City of Ryde Submission

Ivanhoe (Midtown) Primary School
SSD-56124984

Submission Date: 1/11/ 2023
COR2023/90/1

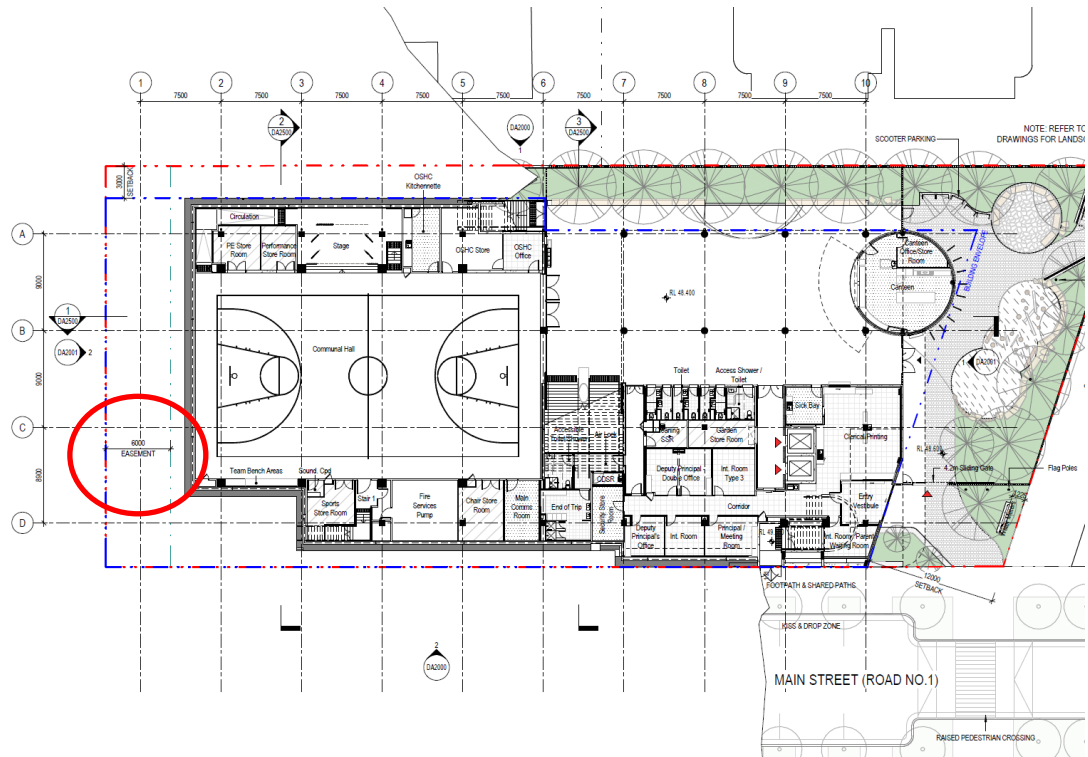
The development relies on 10 parking bays shown on the Main Street (which may also be shared as a bus set down area). In this regard, the TIA report states that “this method of calculating the required number of spaces was discussed and supported during Transport Working Group 2” (refer to page 19 of the TIA report). However, Council’s traffic engineers attended the meeting and did not express any support as they needed more time to review the calculation for the required drop-off / pick-up spaces presented in the meeting.

It is noted that calculation of the number of drop-off / pick-up spaces (as shown in Table 2-3 of the TIA report) is based on 2 mins dwell time per pick-up/drop-off space. However, considering the indented kerbside parking bay design, which increases the manoeuvring difficulties of pulling in/out of the bays, and the congestion on Main Street during peak periods, it should be assumed to at least double the dwell time or more, which would lead to 20-25 required pick-up/drop-off spaces.

In supporting the mode share target of reducing the school vehicle trips, as stated in the School Transport Plan, Council recommends applicant to provide at least 25 pick-up/drop-off spaces on site consistent with the Condition A18 (e) of Concept Approval (SSD-8707).

Figure 2: Markup of Ground Floor Plan

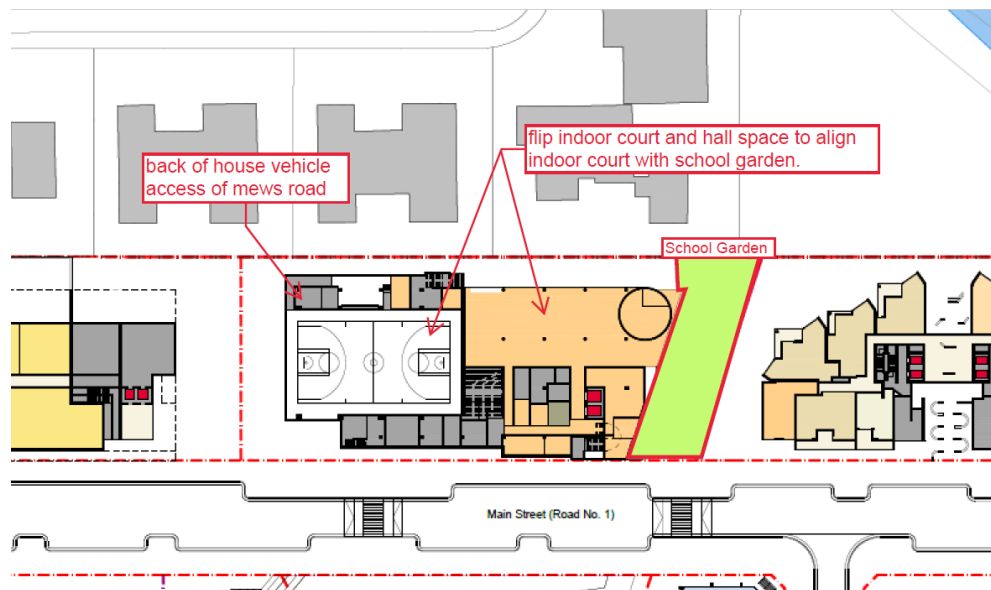
- g. Council's preference is that the indoor court has a direct relationship with the 'School Garden'. This is due to the future community use of the indoor court and the 'School Garden' outside of school hours. Both facilities compliment the activation of the other. This will also assist in reducing the number of security access points into the school outside of school operating hours. The indoor court should be moved to eastern adjacent to the school garden as shown in figure 2 below.

Figure 3: Corridors and covered areas shown as outdoor open space

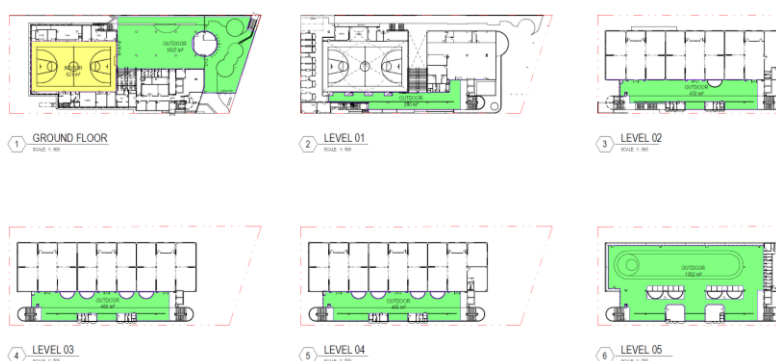
The proposed outdoor spaces except the roof are questionable as outdoor spaces, having not overhead openness to the sky and in most cases limited side openings. These spaces are enclosed spaces without glass, they will need to be artificially lit, heated, and ventilated.

Figure 4: Location of Substation

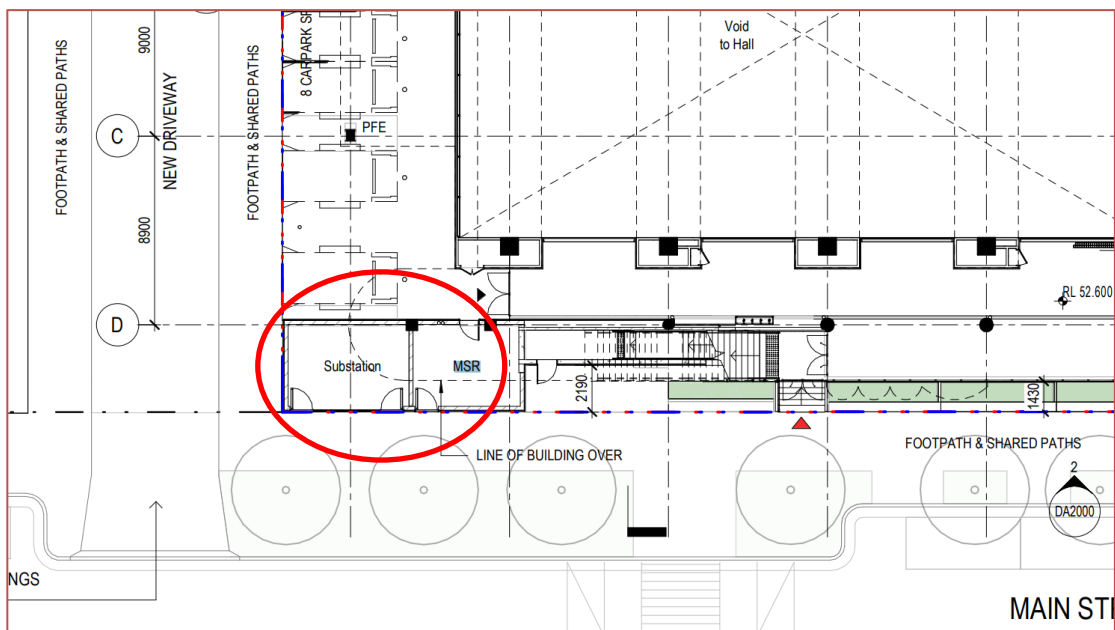
- a. Several design issues that are being raised in this submission could be resolved if the following occurs:
 - The building footprint is reduced
 - floor to ceiling heights are increased
 - the front setback is increased
 - all uses currently shown in a basement configuration are relocated above ground and underground carparking is provided.
- b. **Sightlines blocked.** Substation and MSR structures are proposed on the front boundary and right on the intersection of the proposed driveway (refer to figure 4 below). With the pedestrian access, shared user path, parking at grade adjacent to it and the entry driveway will create an extremely unsafe environment for the students and parents using the space which is also adjacent to pedestrian crossing and drop off zone. A clear splay must be provided at the corner and the structure moved back from the front boundary alignment.

Figure 5: Flood Information

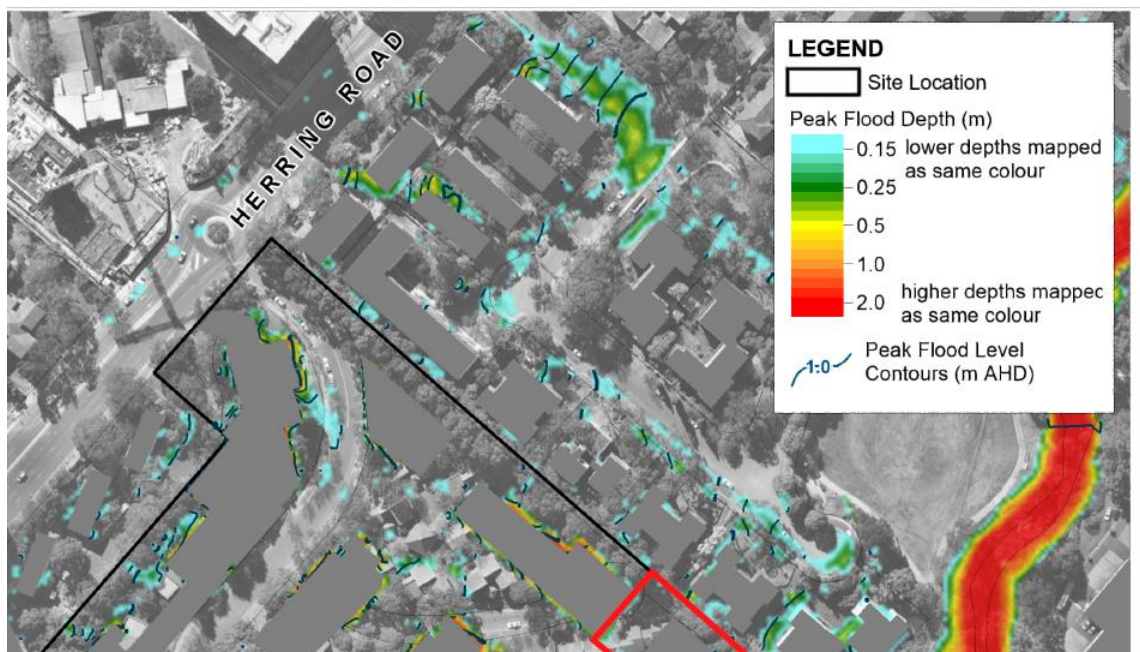
- The pre and post development flood levels are to clearly be shown, inside the property and inside the neighbouring properties.
- Flood Impact maps shall be submitted showing the variation in Flood Levels between the pre and post development scenarios for 1 in 100 yr ARI and PMF storm event. Flood Impact maps shall have 10-20mm intervals.

Note: please provide clarification of the Peak flood depth (e.g. peak 1-100 yr ARI or storm event). The intervals for the Peak flood depth are not acceptable as the gap is too large that cannot show precise condition.

Figure 9: Architectural Plan (not showing drainage assets)

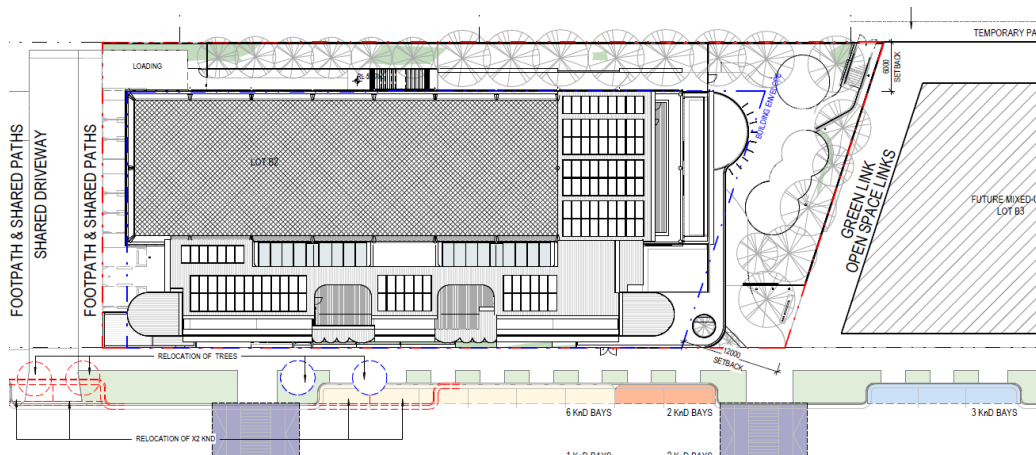
- All council drainage assets including pits and pipes and drainage easements must be clearly shown on the plan.
- The horizontal clearance from the proposed development to the existing pipe/drainage easement to be shown on the plan.
- The finished floor levels are to be clearly shown on the plan and shall match the ones instructed in the final Flood Report.
- Architectural plans must ensure that no encroachment to the easement is proposed. Please see below screen shot of the Architectural plan showing that Council drainage assets are not depicted on the plan.

Figure 10: Location of trees 11 and 13.

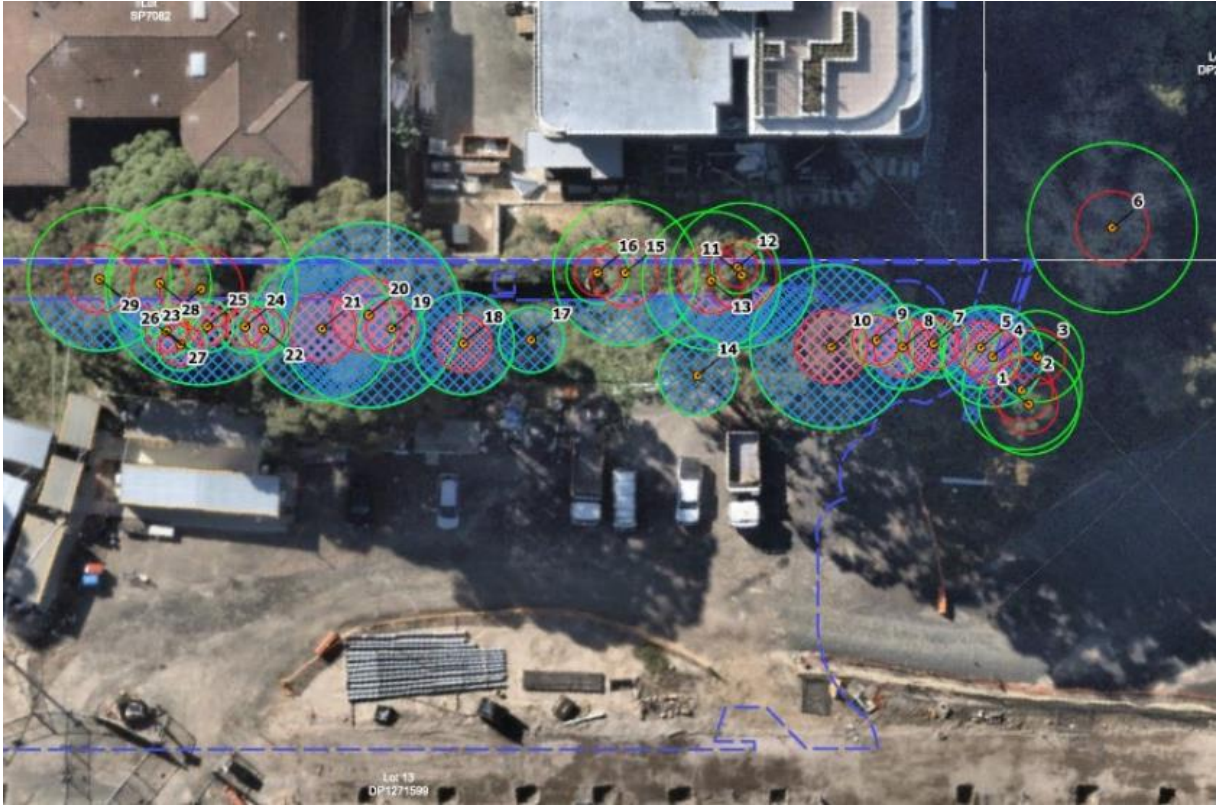
Trees being removed are within development footprint. The area contains native trees but not in biodiversity values mapped area but in close proximity to the Sydney Turpentine Ironbark Forest, which is an endangered ecological community and the Sydney Coastal Enriched Sandstone Forest. It is recommended that the building be redesigned and Tree 11 and 13 – *Eucalyptus saligna* be retained because it would benefit the local canopy cover as both these trees are mature with a high retention value. It also belongs to the nearby Sydney Turpentine Ironbark Forest. It is further suggested that *Verbena bonariensis* not be used as mentioned in the Landscape Report for landscaping.

The above trees are located close to the rear boundary of the lot and are affected due to the changed building footprint. The required 10m setback as per the Concept Approval would retention of a greater number of trees.
